CARDINAL

CARDINAL REVISION LIST - STRUCTURAL:

CARDINAL REVISION LIST - ARCHITECTURAL:

DREAM FINDERS HOMES CARDINAL

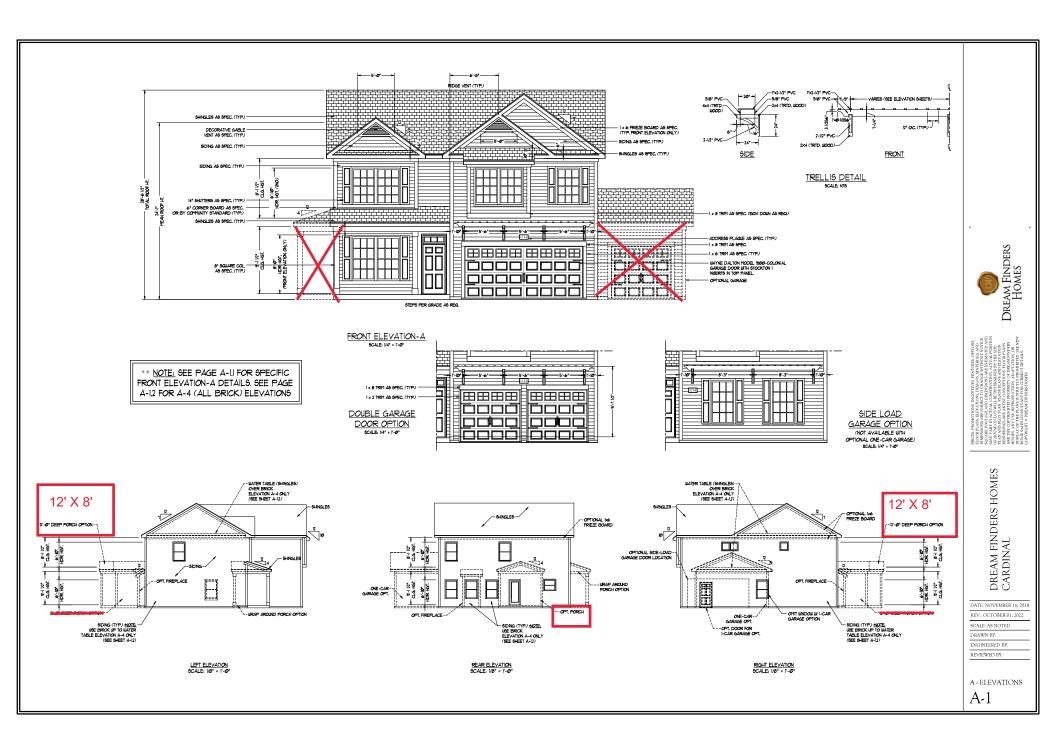
CHANGES ON 10:01-22

- 12. ADDED OPTIONAL 3/0 5/0 WINDOW TO SIDE OF HOUSE IN DINING ROOM
- 13. ADDED OPTIONAL DOUBLE OVEN TO KITCHEN FOR "GOURMET KITCHEN"

CHANGES ON 10-26-22

- 14. REMOVE CLOSET FROM FOYER
- 15. ROTATE POWDER AND PANTRY
- 16. MOVE DOOR IN KITCHEN, REMOVE ADJACENT 3/0 x 3/0 WINDOW
- 17. EXTEND THE KITCHEN COUNTERTOP AND LARGER ISLAND OPTION

SECOND FLOOR ELECTRICAL PLAN

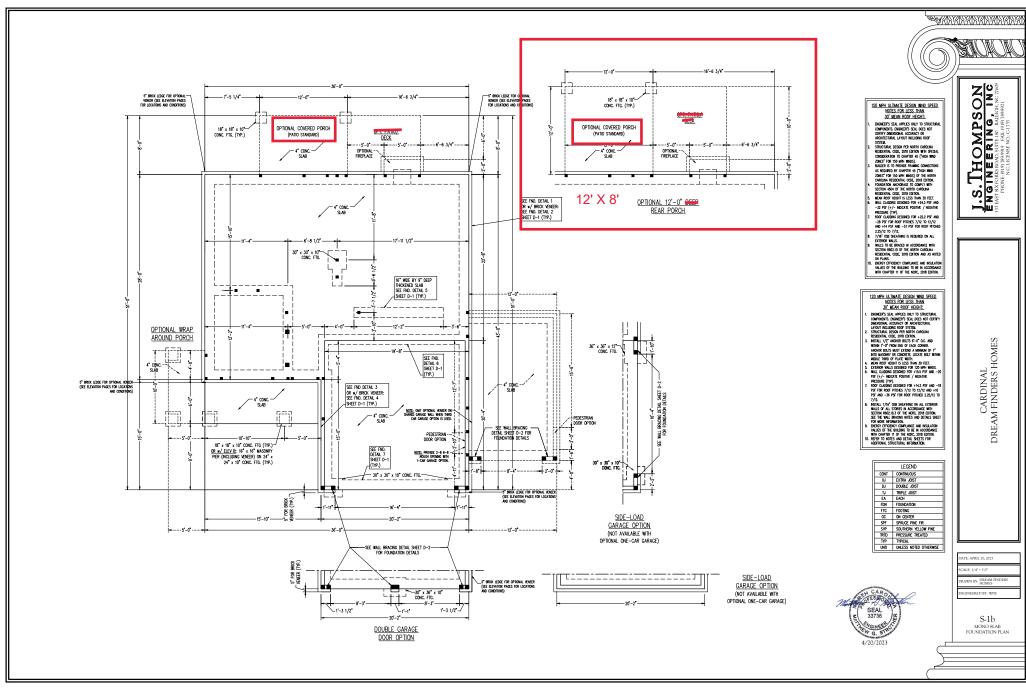
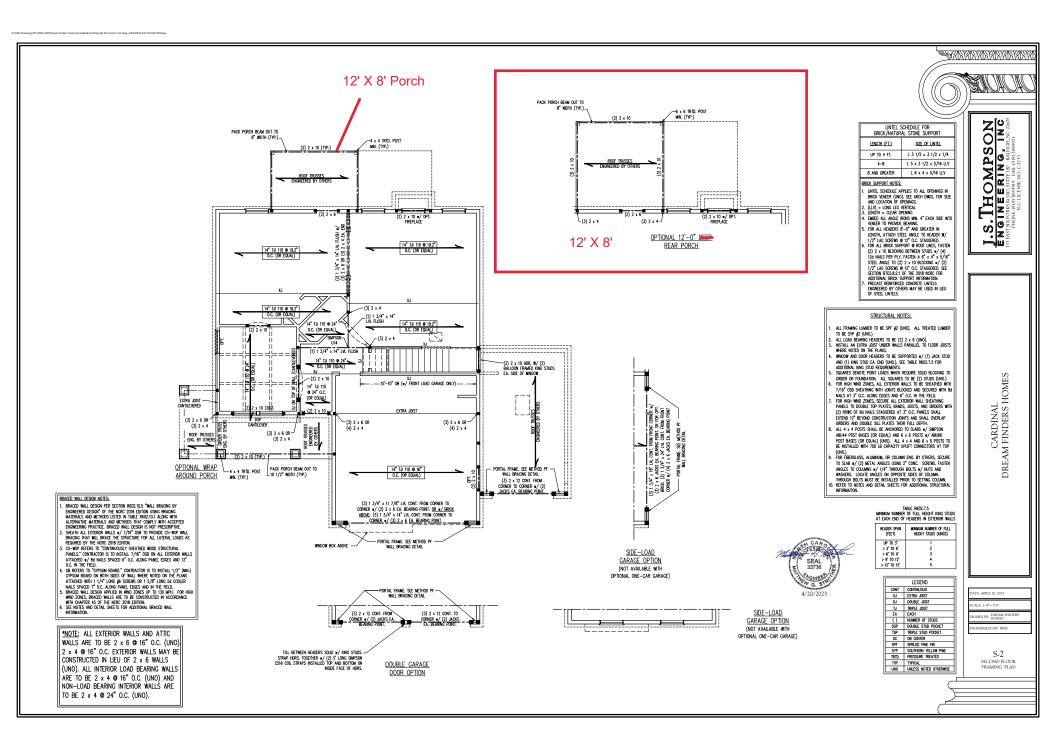
- I. CHANGED FRONT LOAD GARAGE DOOR EXTERIOR WALL AND NOTE TO REFLECT 2X6 WALL IN LIEU OF 2X4 WALL (11-18)
- 2. ADDED CLOSET SHELVING NOTES. (11-18)
- 3. ADDED LIGHT TO STAIRS SHEETS E-1 AND E-2 (11-18)
- 4. CHANGED ALL DOUBLE STUD POCKETS BETWEEN WINDOWS TO TRIPLE STUD POCKETS (11-18)
- 5. REMOVED ALL BRICK FRONT ELEVATIONS FROM ELEVATION OPTION SHEETS (11-18)
- 5. ADDED ONE CAR GARAGE OPTION AND WRAP PORCH OPTION TO ELEVATION OPTION SHEETS (11-18)
- 7. CHANGED GARAGE DOOR INSERTS FROM STOCKTON 2 TO STOCKTON 3 ON ALL "B" ELEVATIONS. (11-18)
- CHANGED SIDING NOTES TO SPECIFY FIBER CEMENT SIDING ON A-4, B-4 AND C-4 ELEVATIONS. (11-18)
- 9. UPDATED FLOOR PLAN "WALL NOTES" (11-18)
- 10. MADE FIREPLACE AN OPTION AND MADE SINGLE WINDOW IN SAME LOCATION STANDARD (11-18)
- 11. UPDATED CUTSHEETS TO NEW FORMAT (11-18)
